PROPOSED TECHNICAL SPECIFICATION CHANGE

SURRY POWER STATION  
 ORGANIZATION CHART

DISCUSSION OF PROPOSED TECHNICAL SPECIFICATION CHANGE

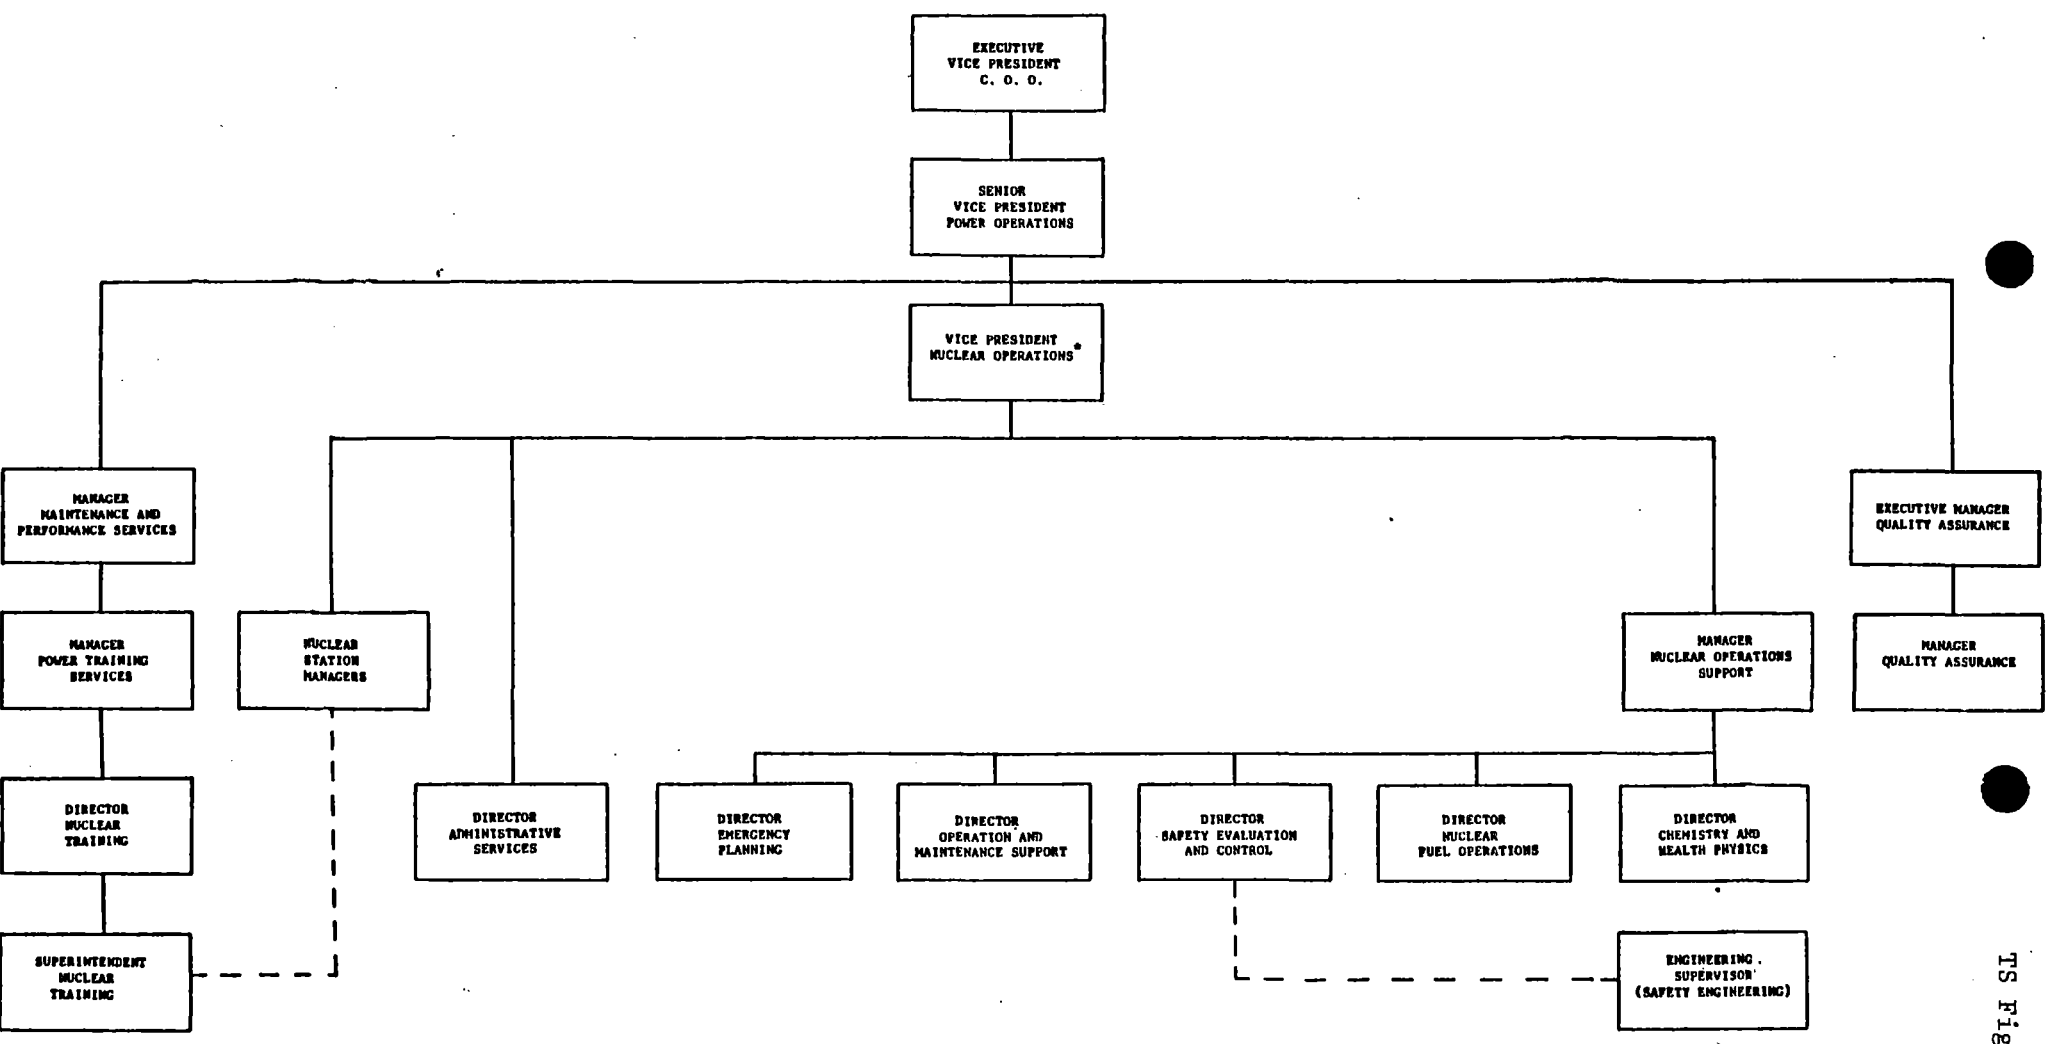
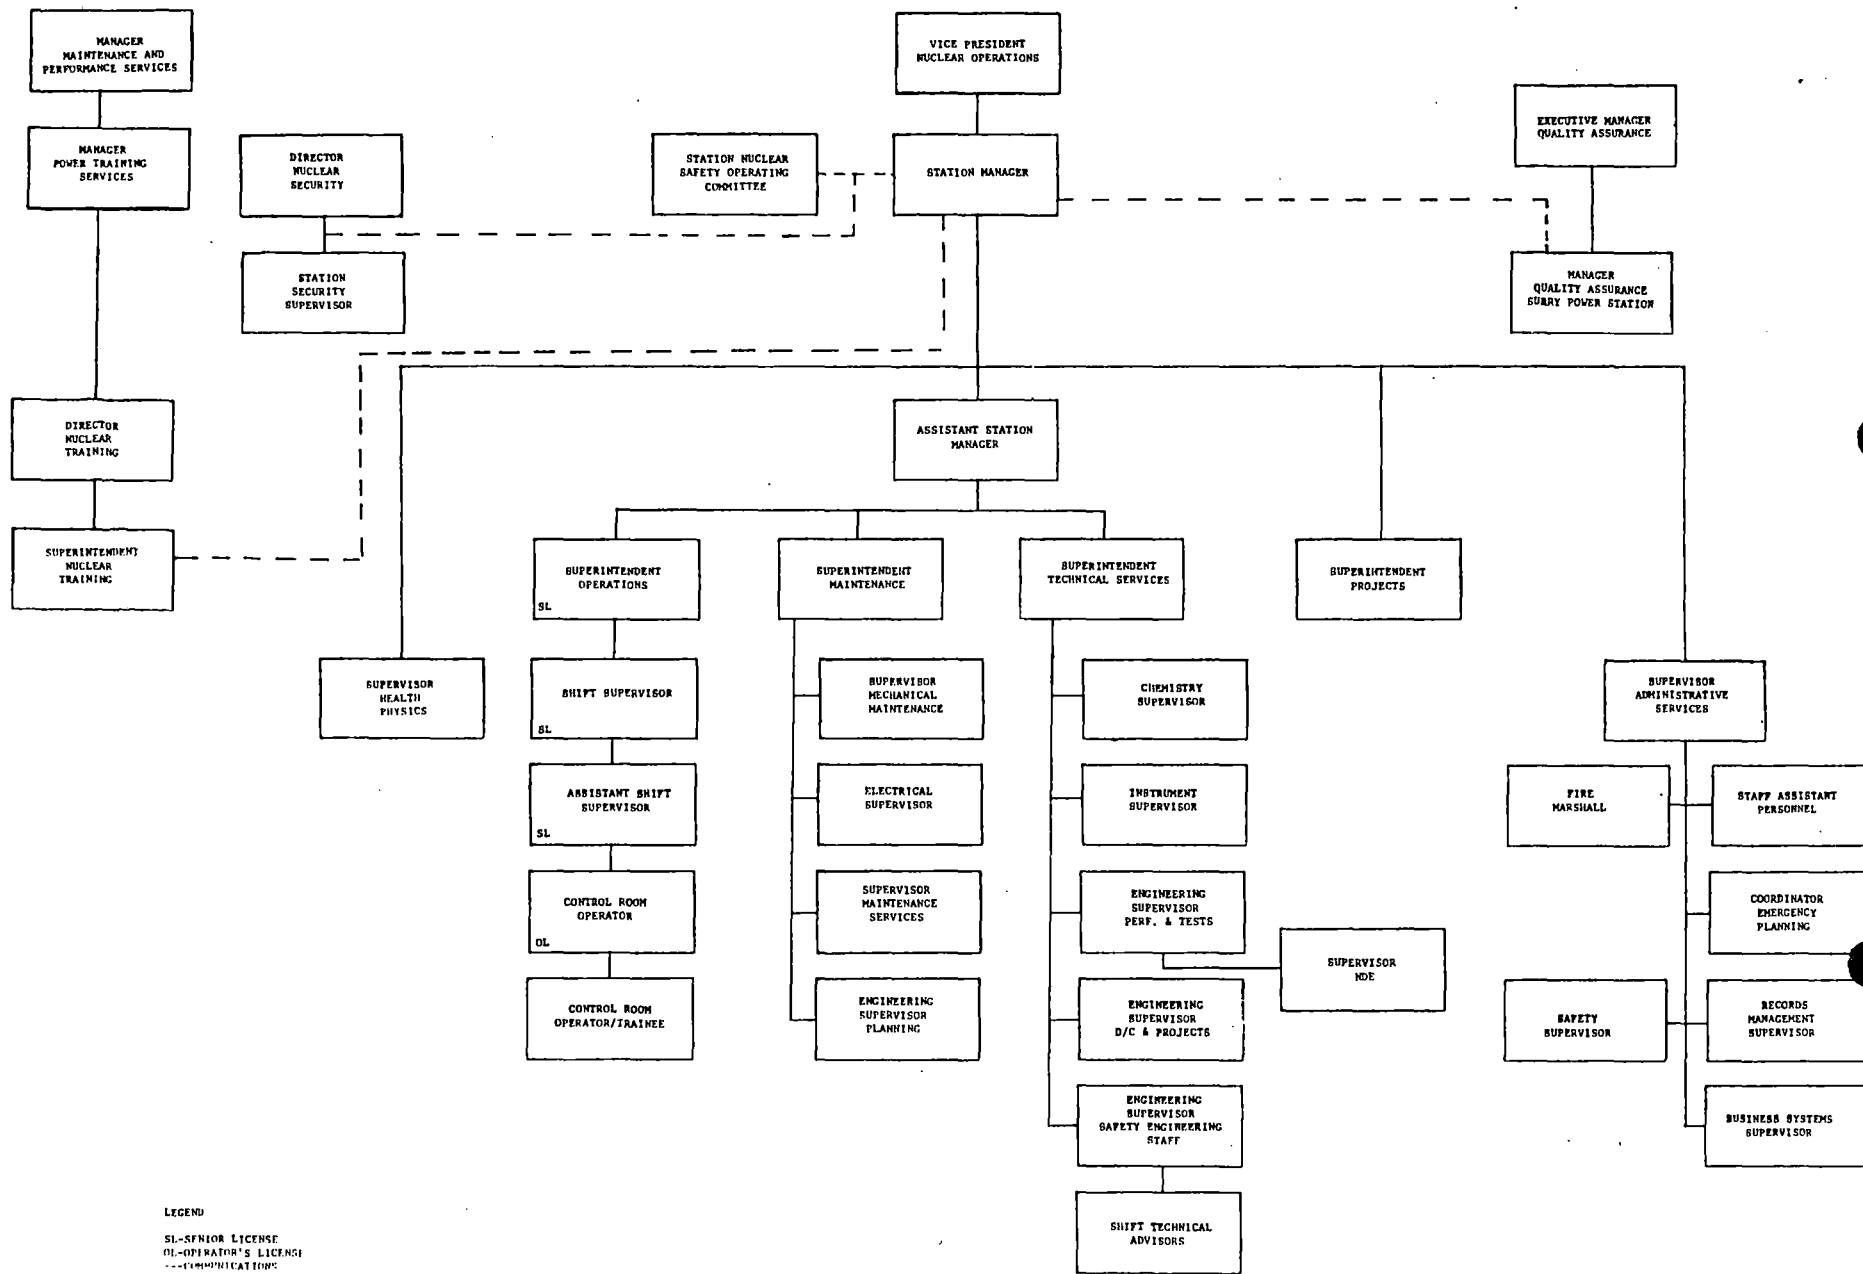
The proposed Technical Specification changes reflect the recent reorganizations within the Nuclear Operations Department and Maintenance and Performance Services Department.

The reorganization within the Nuclear Operations Department and the Maintenance and Performance Services Department will aid in the quality of training activities at the power stations. The Director Training within the Nuclear Operations Department will now be the Director Nuclear Training in the Maintenance and Performance Services Department. The Director Nuclear Training will report to the Manager Power Training Services who will report to the Manager Maintenance and Performance Services who will ultimately report to the Senior Vice President Power Operations. The Director Nuclear Training will have the Superintendent Nuclear Training (who is located at the power station) reporting directly to him. The Superintendent Nuclear Training will have communications with the Station Manager.

The Director Nuclear Training will continue to plan, organize, direct and control nuclear training, so that effective and efficient technical training is provided to Nuclear Operations. The Director Nuclear Training will assess and recommend specific training requirements for regulatory agencies as applicable and coordinate programs offerings as necessary.
